30-039-05772 HALL #005

Southland Royalty Company LLC requests approval to plug and abandon the Hall #5.

CONDITIONS OF APPROVAL

Geologic Report

Proposed P&A

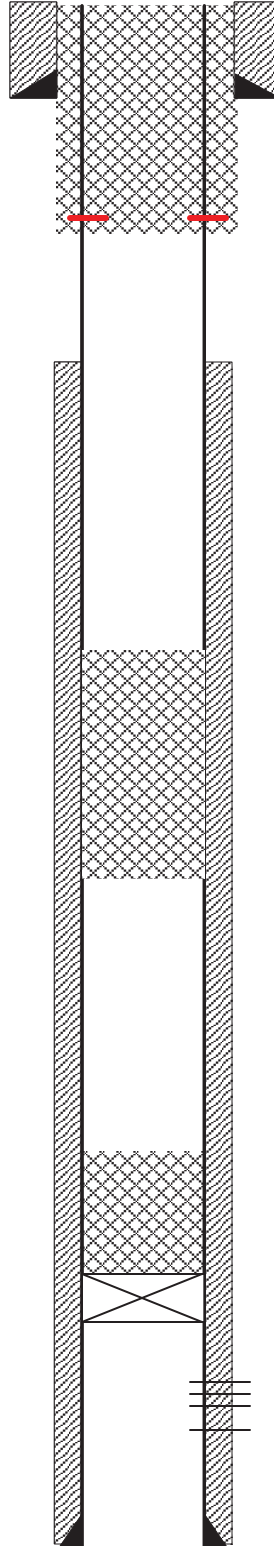
- Notify NMOCD 24 Hours prior to commencing activities
- In addition to APD approved plugs
- Include a plug, 2250-2150.' OCD Nacimiento top @ 2200.'
- Include a plug, 3404'-3304.' OCD Kirtland top @ 3354.'

- a. BLM tops are based on the attached geologic report. Plugs will be adjusted based on cement coverage indicated by the CBL. Do not proceed with any additional plugging operations prior to reviewing CBL results with BLM and confirming plug depths.

4. All plugs must cover 50 feet above and below indicated formation. Minimum inside plug 100 feet plus 50 feet excess cement. See attached BLM geologic report.

- a. BLM Fruitland formation top (3434 ft md). Plug: 3484-3384
 - b. BLM Ojo Alamo formation top (3184 ft md). Plug: 3234-3134
5. Minimum surface plug is 50 feet deeper than surface casing to surface. Perforate production casing at least 156 feet or deeper for surface plug.

- Please ensure that the tops of the Pictured Cliffs and Fruitland formations as well as the entire Ojo Alamo aquifer, identified in this report, are isolated by proper placement of cement plugs. This will protect the freshwater sands in this well bore.
